AB McLAUCHLAN :: WELLIVER METAL

**Service Bulletin #07-88  
December 5, 1988**

**Attention: Parts Manager and Service Manager  
RE: High Pressure Check Valves (part # 500-044)**

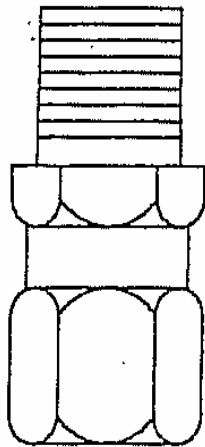
The new style hardened Valves do not always provide "Zero Leakage" which is required on Hand Pumps (to prevent "Bleed Off" from the cylinders). Starting at paver serial number H-10107-B-8 we are reverting back to our original check valves in ALL HAND PUMP applications. The Hand Pump check valves will be part # 500-044. The hardened seat check valves (now to be used in D-550 Pavers ONLY) will now be part # 550-108.

The two check valves are readily identifiable by sight. When a customer orders 500-044 check valves, it will be NECESSARY to determine what model paver they are going to be used on and supply the proper one. DO NOT INTERCHANGE these two different check valves.
